VIRGINIA ELECTRIC AND POWER COMPANY
RICHMOND, VIRGINIA 23261

VIRGINIA ELECTRIC AND POWER COMPANY
NORTH ANNA POWER STATION UNIT 2
RESPONSE TO REQUEST FOR ADDITIONAL INFORMATION
THIRD INTERVAL INSERVICE INSPECTION PROGRAM

**Request for Additional Information
North Anna Power Station Unit 2
Third Interval Inservice Inspection Program**

DETAIL A

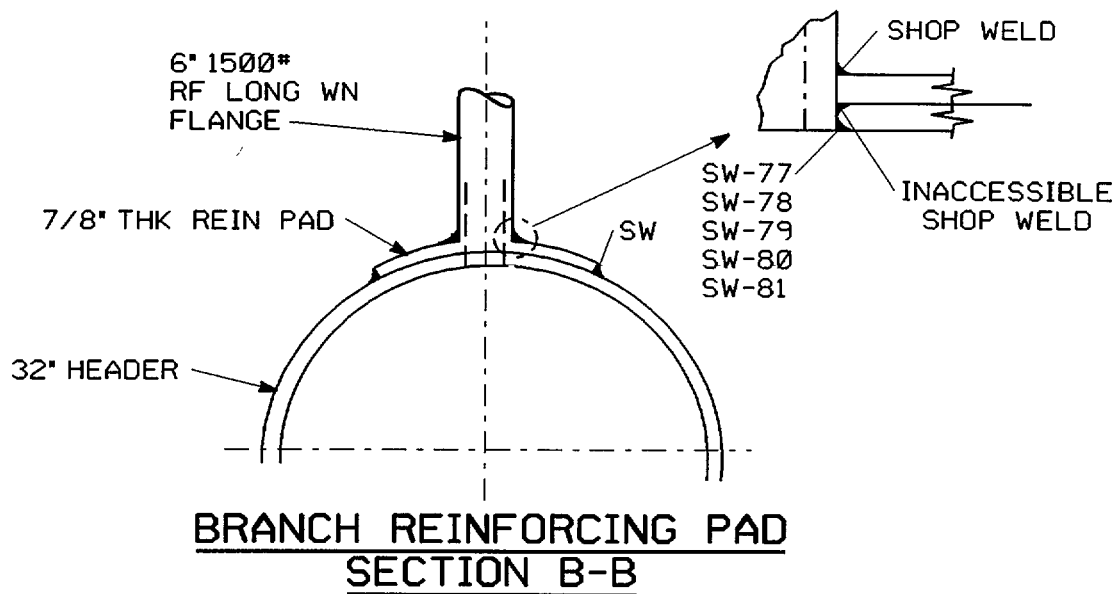
Request for Relief NDE-001 – The licensee submitted an alternative to perform surface examinations of the pipe-to-pipe fillet welds of the reinforcement pads associated with each branch connection weld. In order for the proposed alternative to be acceptable, please provide the following:

1. Please provide sketches or photos with sufficient details so that the staff could determine the impracticality in performing the Code-required surface examinations of the subject welds.

Response: The following two "Detail Sections" were taken from drawing 12050-WMKS-101A-1, which is referenced in the request for relief. They are typical of the three sets of branch connections included in NDE-001.
